Air Injection System MIL "ON"

REVISION NOTICE

SUPERSESSION NOTICE

Introduction

Figure 1.

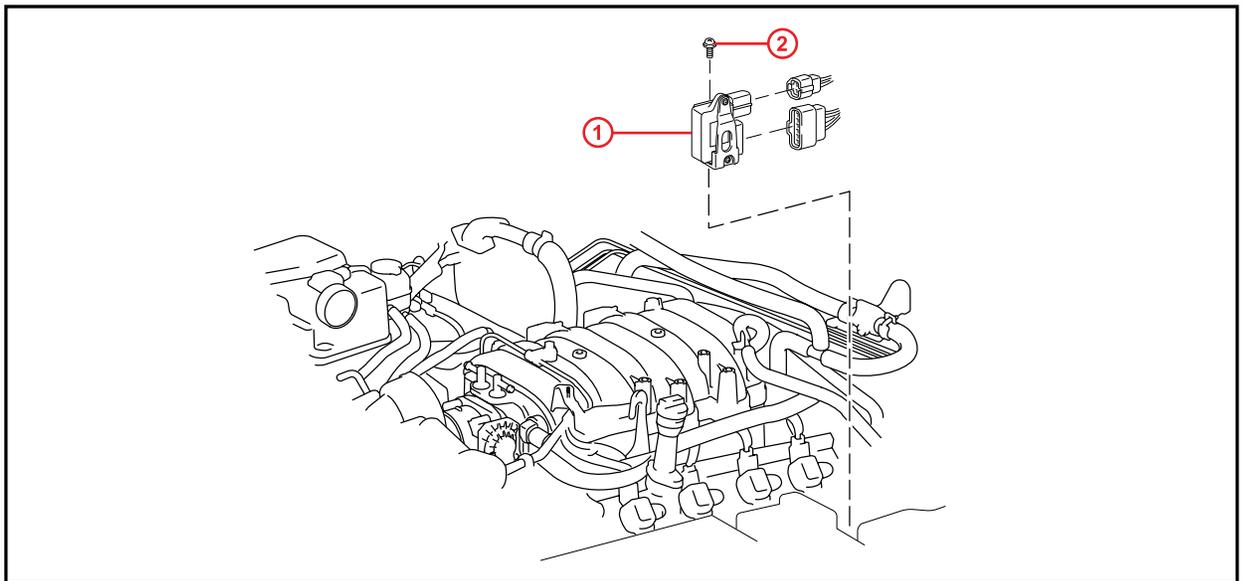
- If MIL illuminates, or a DTC is detected, proceed to step 6.
 - If MIL does not illuminate, or a DTC is not detected, proceed to step 8.
6. Using Techstream, check for DTCs. If P0418 and/or P2445 are present, replace the Air Injection Control Driver.

1 Air Injection Control Driver

2 Specified Torque: 7.5 N*m (76 kgf*cm, 66 in*lbf)
